1961 Corvette: Service Bulletin: Corvette Grille Vibration

Subject: Corvette Grille Vibration

Bulletin No: Page 1, Section XIII, Group 2

Date: February 2, 1961

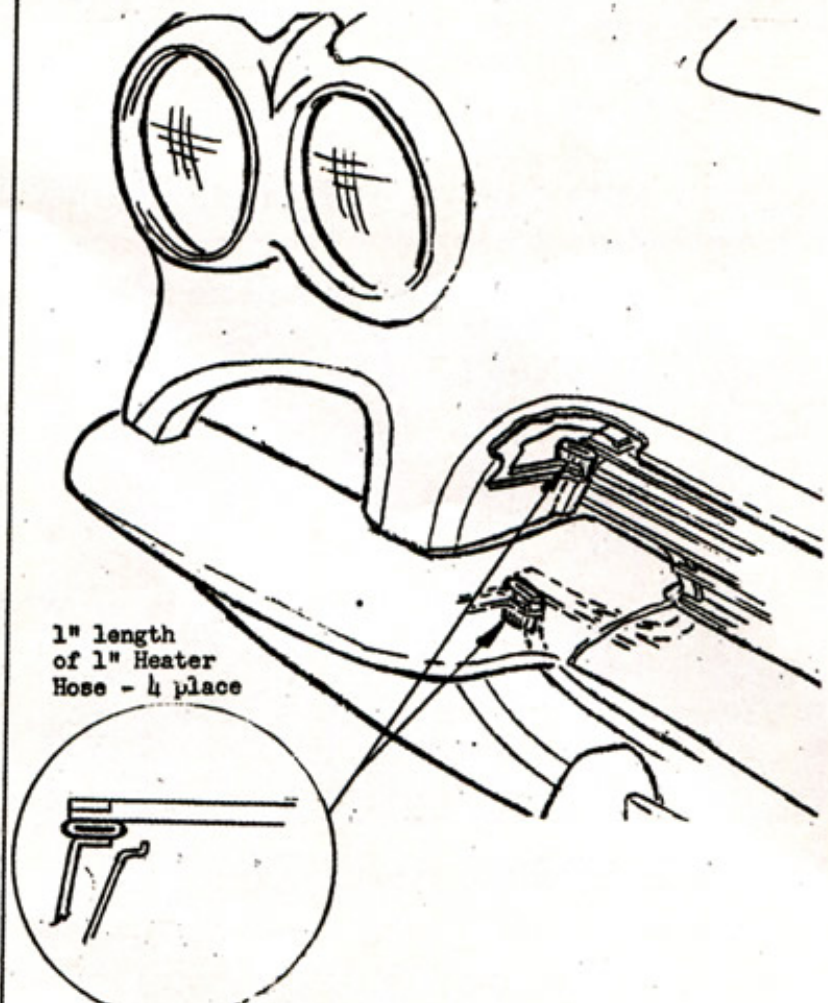
A shrill whistling noise on early production Corvette Models at speeds of 40-60 MPH may be caused by grille vibration. The condition can be minimized by wedging four (4) one inch long pieces of one inch I.D. heater hose between the grille and front end sheet metal as illustrated.
